KEADBY 3 CARBON CAPTURE POWER STATION

Document Ref: 10.2

ES Addendum Non-Technical Summary for Consultation

Date: February 2022

Figure NTS5: Order Limit Changes

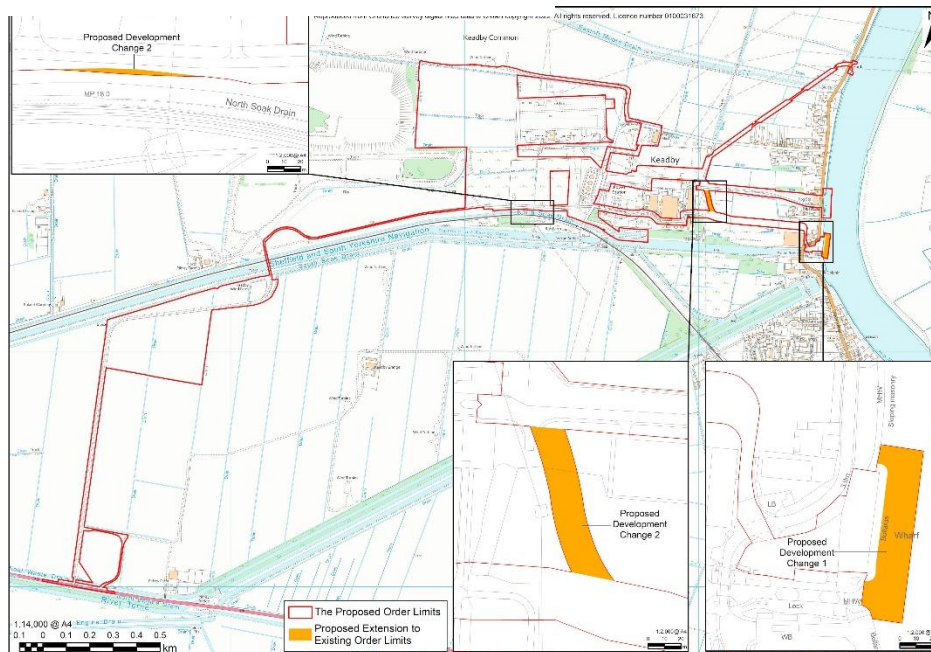
2.2.4 The majority of the Proposed Development Changes are located within the Order Limits submitted with the DCO Application (as shown on APP-101). However, two minor changes to the Order Limits as a result of the Proposed Design changes are required, as shown on Figure NTS5 below.

2.2.5 The two Proposed Development Changes that affect the Order Limits are as follows:

- Proposed Development Change 1: addition of a section of river bed to be used by moored vessels in the Waterborne Transport Off-loading Area.
- Proposed Development Change 2: Extension to the Abnormal Indivisible Load (AIL) Route through Keadby 1 Power Station outage/contractor compound, which runs through semi-improved grassland/scrub and hardstanding land occupied by services.

Figure NTS6: Visualisation of the Proposed PCC Site based upon maximum dimensions and Twin absorbers

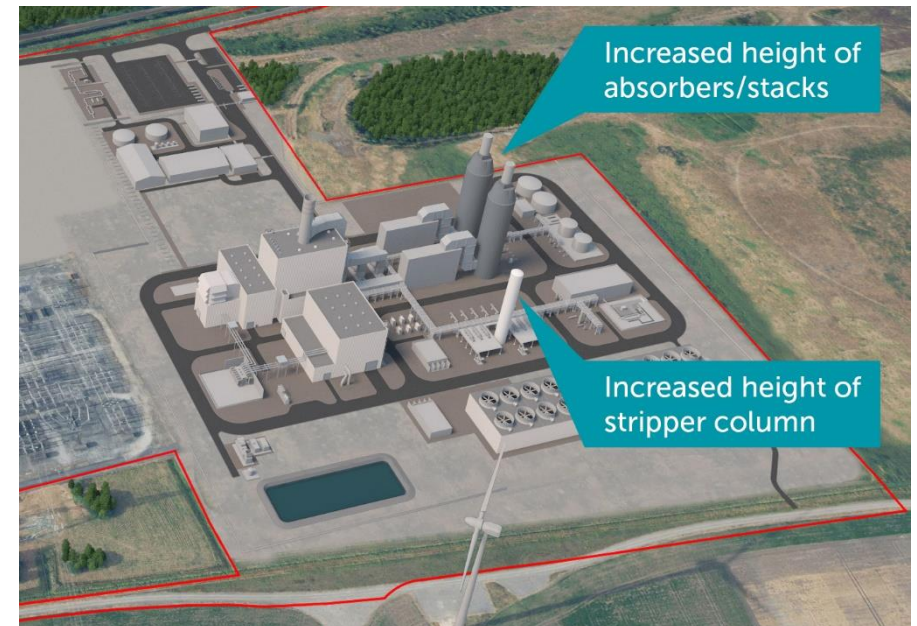
- **Change 3: Increase to the maximum heights of the carbon dioxide absorbers/ stacks, if two are installed.** Ongoing engagement with design contractors has identified that in the event that two absorbers are required for the removal of CO₂ from flue gases within the CCP (Work No. 1C), the twin absorber units and stacks may extend to a maximum height of up to 80m above ground level ('AGL') for the absorber towers and an additional up to 15.5m in height for the stacks i.e. up to 95.5m AGL in total, which equates to a maximum of 98.3m Above Ordnance Datum (AOD) for each absorber and associated stack. These maximum dimensions – established through ongoing design development - are approximately 20m higher than those previously assessed for the twin absorber option in the Original ES and presented as a parameter in the draft DCO [APP-005].

3.2.3 **Figure NTS6** shows the visualisation of the Proposed PCC Site based upon the proposed revised maximum dimensions, twin absorbers and the change to the Proposed Development Site boundary.

Figure NTS7: Indicative Proposed PCC Site Layout Single Absorber

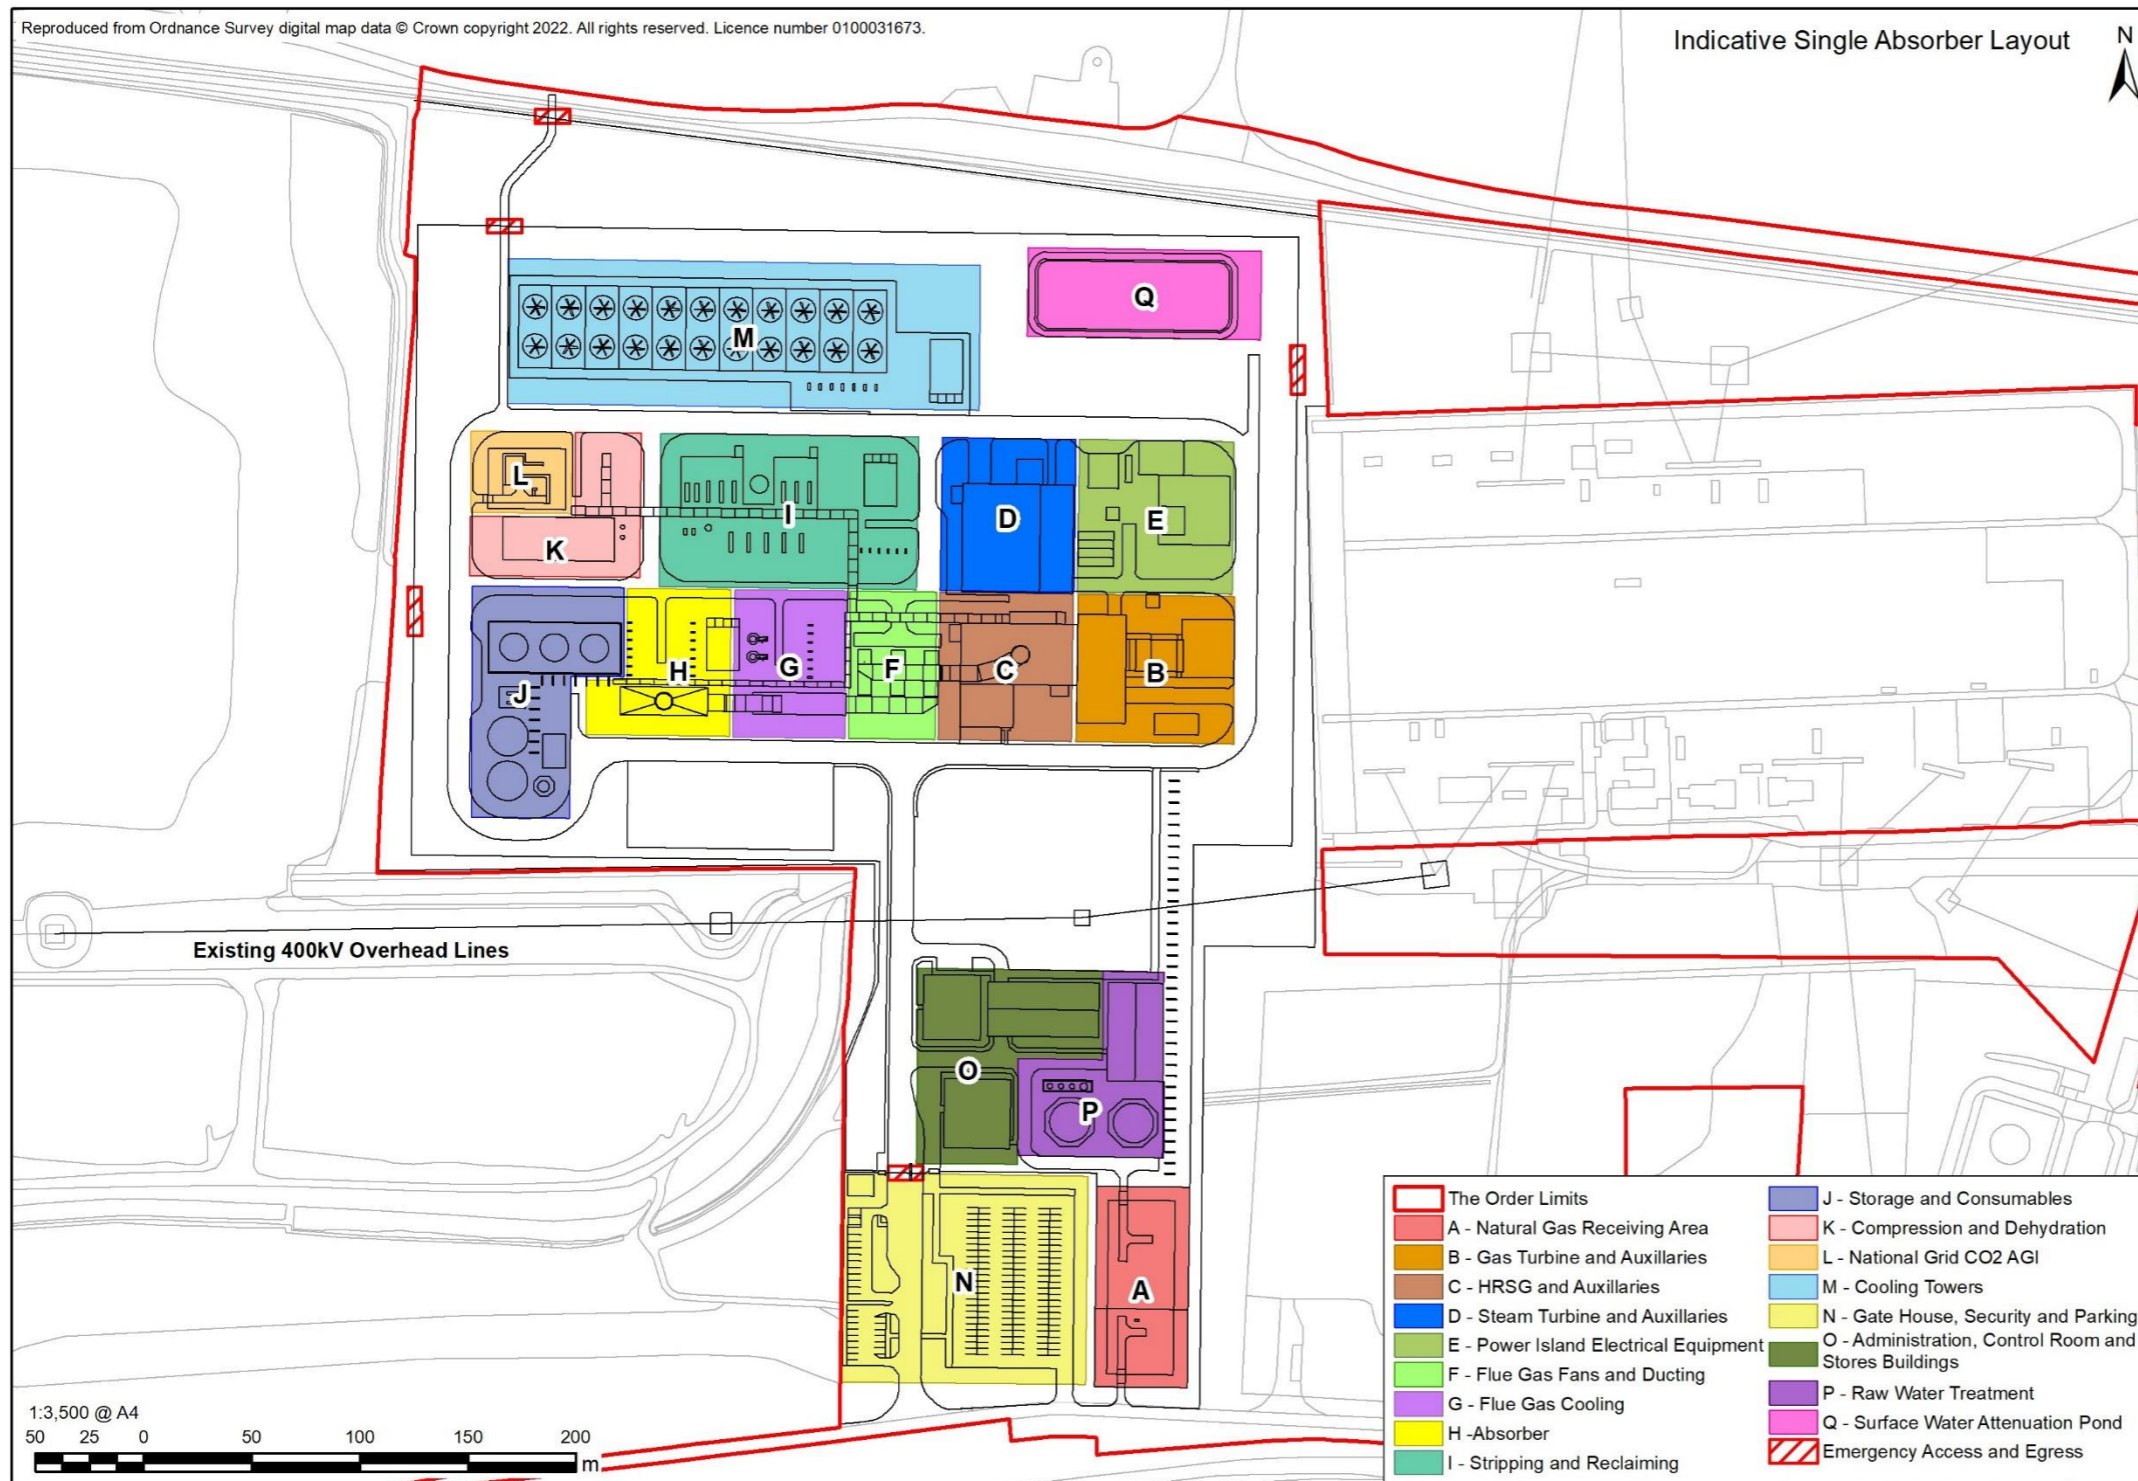
3.2.4 **Figures NTS7 and NTS8** show an indicative layout of the Proposed PCC Site. Figure NTS7 shows the indicative layout of the Proposed PCC Site with a single absorber installed. Figure NTS8 shows the indicative layout of the Proposed PCC Site based on the twin absorber option. The CCGT and CCP including absorber stack(s) would still be located within the defined Work Areas 1A and 1C (Application Document Ref. 4.3) i.e. within the Main Site on the northern part of the Proposed PCC Site.

Figure NTS9: Abnormal Indivisible Load Route from Wharf

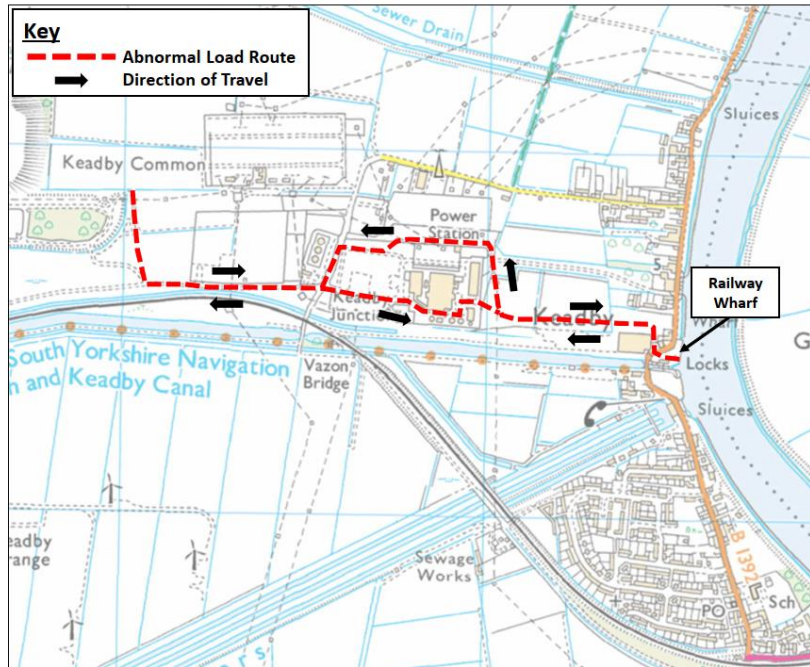
- **Change 2: Changes to the Additional Abnormal Indivisible Load Route, largely within SSE land (Work No. 10A)**. The Applicant proposes an extension to the AIL Route (Work No. 10A), to avoid reliance on routing all AILs through Keadby Power Station due to this being an operational site with the potential for health and safety risk management practices to affect the construction timescale and the speed of deployment of this nationally significant infrastructure. This extension utilises land within the Keadby power station site that is currently used as a contractor/ outage compound area, east of Keadby 1 Power Station and north of Keadby 1 Power Station which is all within land under the control of the Applicant. Demolition/ relocation of several small existing Keadby 1 Power Station buildings/ offices within this area may be required. The route would seek to avoid loss of and disturbance to existing vegetation, although where permanent loss of vegetation is unavoidable, compensation/ enhancement of biodiversity including replacement tree planting would be undertaken. Temporary steel bridges will be used to span two drainage ditches (as was the case during the construction of Keadby 2 power station).

- Where the route of the Additional AIL route crosses existing services including Keadby 1 cooling water pipework, a temporary piled steel bridge structure would be used to minimise risk of damage to the pipework and other services. Other parts of the AIL route extension would be constructed using similar materials and techniques to the existing retained AIL Route created for Keadby 2 Power Station construction. Vehicles using the AIL Route extension to deliver AILs would travel west along the northern boundary of Keadby 1 Power Station, within the Order Limits, and then cross Chapel Lane making use of existing site roads adjacent to the existing above ground tank farm to re-join the existing AIL Route along Bonnyhale Road. A very minor increase (0.02ha) to the Order Limits south of Bonnyhale Road is also proposed to allow oversail of the largest AIL components. This area is within the Applicant's land.

- **Change 1** does not result in any changes to construction activities.
- **Change 2:**
 - The temporary haul road will be constructed using geotextile separation membrane with granular compacted stone laid on top and using a temporary piled steel bridge to span the Keadby 1 cooling pipeline.
 - Temporary steel bridges will be used to span two drainage ditches
 - A very minor increase (0.02ha) to the Order Limits south of Bonnyhale Road is also proposed to allow oversail of the largest AIL components. This area is within the Applicant's land.
 - Following construction of the extension to the AIL Route, enhancement of habitats within the route will be undertaken as part of the overall landscape and biodiversity management and enhancement proposals (**Work No. 11a**).
